Permit # 931217 City of Portland BUILDING PERMIT APPLICATION Fee 395 Zone MMSV Map Lot#

Address: 32 Alice St. Date: 29/Dec/93  
 Reason for Permit: To Construct a Single Family Dwelling  
36' x 40' (No garage) Bldg. Owner: Michael Howell  
 Contractor: D. W. Builders  
 Permit Applicant: Wayne Wolcott  
 Approval: \*1 \*2 \*6 \*7 \*9 \*10 \*12 \*13 \*14 \*15 \*16

December 29, 1993

Re: 32 Alice St

BUILDING PERMIT REPORT

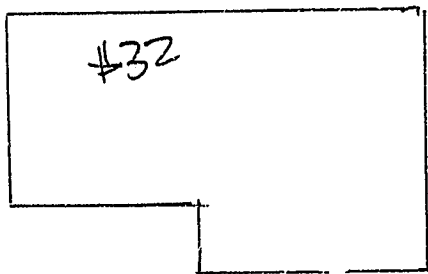
- 1.) All above ground L/P storage tanks shall be located in accordance with NFPA #58 standards.
- 2.) Any tank located near the path of vehicle movement shall be protected with appropriate permanent barricades.
- 3.) All piping shall be protected from possible mechanical damage and vandalism.
